Access Compliance Report Public Rights-of-Way (Curb Ramps)

Main Street: MCFADDEN_AVE Cross Street: PACIFIC_ST Location: NW

ADA ID: RPRK211005181541 Ramp Type: Type 1 - Perpendicular Diagonal Initial Pass/Fail: Fail Overall Compliance: No Severity Score: 32

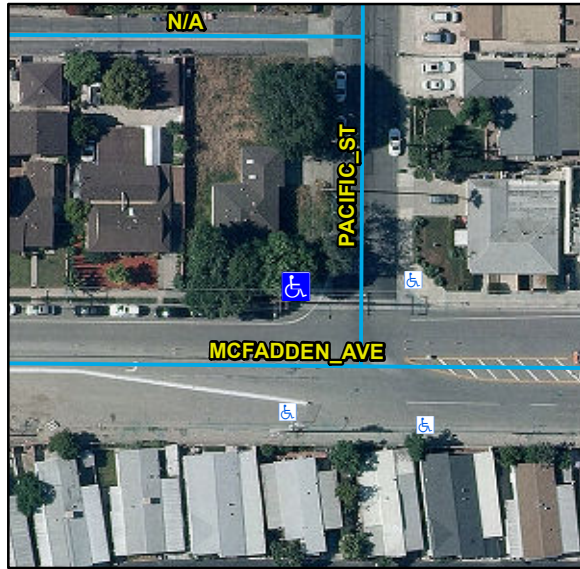
Compliance	Description	Data	Compliance	Description	Data
N/A	Ramp Length (in)	103	N/A	Flare Type LT	
Yes	Ramp Width (in)	48			N/A
No	Ramp Run Slope (%)	12.9	N/A	Flare Slope LT (%)	N/A
No	Ramp Cross Slope (%)	2.3	N/A	Flare Traversable LT	N/A
N/A	Landing Present	N/A	N/A	Flare Type RT	
N/A	Landing Length (in)	N/A			N/A
N/A	Landing Width (in)	N/A	N/A	Flare Slope RT (%)	N/A
N/A	Landing Run Slope (%)	N/A	N/A	Flare Traversable RT	N/A
N/A	Landing Cross Slope (%)	N/A	N/A	DWS Provided	N/A
N/A	Landing Movement Obstructed?	N/A	N/A	DWS Contrast	N/A
	Landing Movement Type	N/A	N/A	DWS Length (in)	N/A
N/A	Landing Shared	N/A	N/A	DWS Full Width	N/A
N/A	Clear Space	Yes	N/A	DWS Offset Left (in)	N/A
N/A	Clear Space To Crosswalk (in)	N/A	N/A	DWS Offset Right (in)	N/A
N/A	Marked Crosswalk 1	No	N/A	Marked Crosswalk 2	No
	Crossing 1 Direction	S		Crossing 2 Direction	E
	Marked Crosswalk 1 Width (in)	N/A		Marked Crosswalk 2 Width (in)	N/A

N/A	Ramp Inside Crosswalk 1	N/A	Yes	Ramp Inside Crosswalk 2	N/A
	Crossing 1 Slope (%)	6.3		Crossing 2 Slope (%)	1.6
	Crossing 1 Cross Slope (%)	1.6		Crossing 2 Cross Slope (%)	1.4
N/A	Gutter Ponding	N/A	No	Curb Slope	10.3
No	Gutter Lip Height (in)	0.25		Road Run Slope (%)	1.3
N/A	Gutter Run Slope (%)	N/A		Road Cross Slope (%)	6
N/A	Gutter Cross Slope (%)	N/A			
Yes	Overall Surface Condition: Acceptable		Yes	Perp Joint Present	Yes
	Cross Gutter Present?	Yes		Spandrel Present?	Yes
	Replace Cross Gutter?	No		Replace Spandrel?	No

Remove & Replace Curb Ramp With Two New Directional Ramps or Equivalent.
